**ITEMS RECEIVED AFTER THE PRODUCTION OF THE REPORT
FOR THE PLANNING COMMITTEE
TO BE HELD ON 24 NOVEMBER, 2021**

COMMITTEE DATE : 24 NOVEMBER, 2021

Application No.: 2021/01086/FUL	Case Officer: Mr. S. D. Butler
Location: Ty R Waun, Cross Common Road, Dinas Powys	
Proposal: Substantial demolition of existing dwelling and the creation of a replacement dwelling

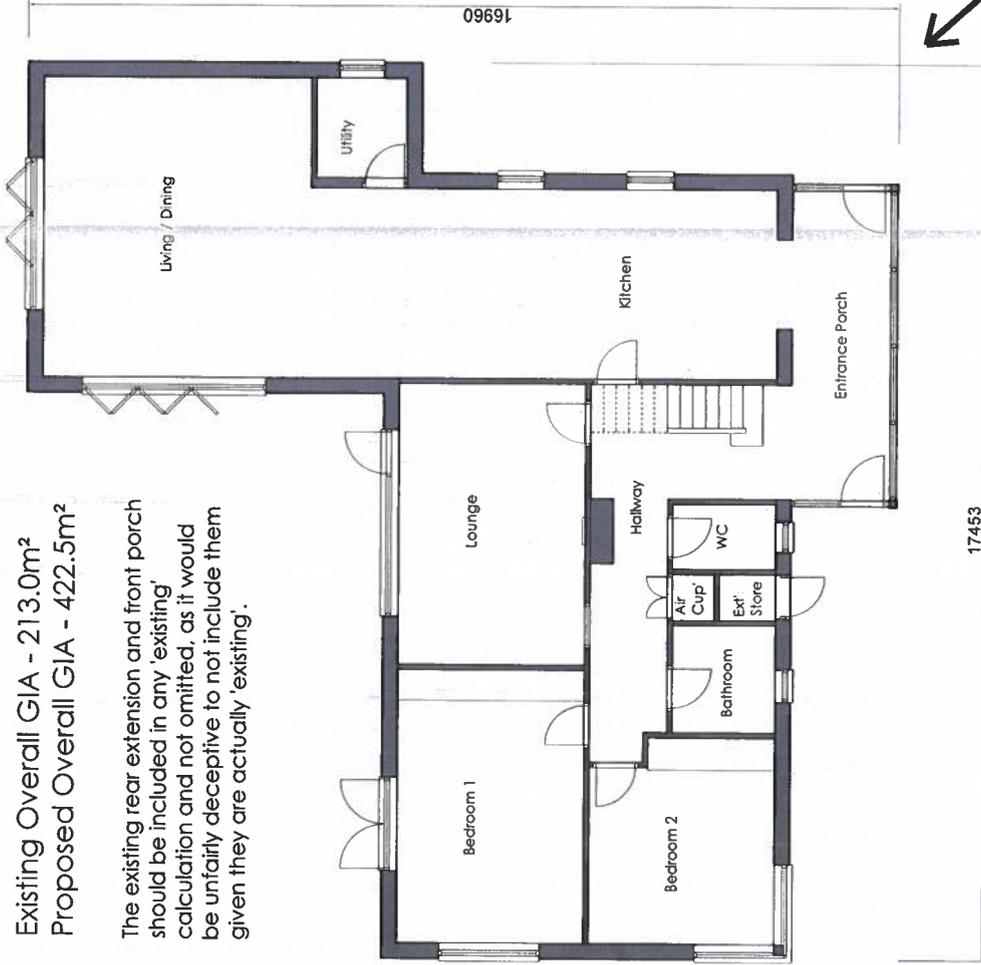
The existing bungalow – we agree with officers that it is of little or no architectural merit and is in a run-down condition

Existing and Proposed Ground Floor Plan Comparisons

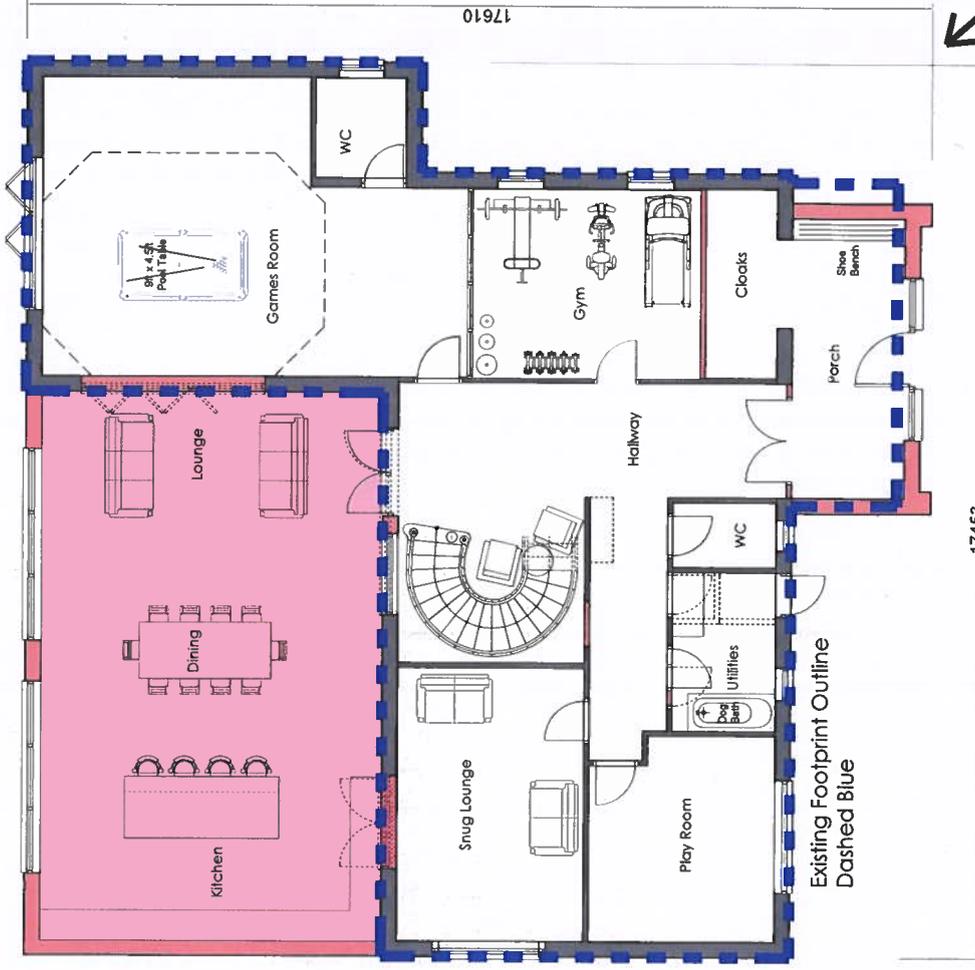
The existing rear extension and front porch should be included in any 'existing' calculation and not omitted, as it would be unfairly deceptive to not include them given they are actually 'existing'.

As the front porch is already existing, it should not be considered that the proposed porch is a 'new' porch, but rather a replacement, as it is.

NOTE: It should be noted the report states the proposed eaves are at 5.8m however they are in fact only at 5.1m, meaning the roofline is much lower than suggested. The existing roof is a much steeper pitch with gables, meaning it actually has a much greater visual impact and larger appearing mass. The proposed roof is shallow pitched and multi-hipped which minimises the appearance and massing of the new roofscape, meaning it is much more in proportion with the proposed dwelling.

Only minor extension to footprint is at the rear of the dwelling, hidden from the PROW view.

Ground - 239.2m² (Only +76.2m² increase)

From the view from the PROW, the overall dimensions of the building are virtually identical between existing and proposed, therefore there should not be so much emphasis on this. The only visible massing increase is vertically, and as clarified this is less than 2.5m increase in height overall. As stated several times in the report the building is largely screened by existing vegetation, barring the isolated view from a single point on the PROW, therefore such a minimal increase in height would not be substantially different. It would not be seen above the existing vegetation and would not provide significant massing differential from the isolated PROW view. We do not consider the proposals to be 'wholly disproportionate' based on these figures and dimensions.

The committee report is clear that the property has previously been extended. Therefore, the property is being increased in floorspace by approximately 227% over the 'original' property size. The calculations provided by the agent are misleading as they include previous extensions/additions.

The agent has also suggested that the committee report is misleading in that it states that the property would have an eave height of 5.8 metres whereas it is only 5.1 metres. This has been checked and confirmed as 5.8 on the submitted plans (see image below).

The agent suggests that the 2.5 metre increase in height would have a minimal impact. The LPA disagree with this assessment and an assessment of visual impact is considered within the committee report.
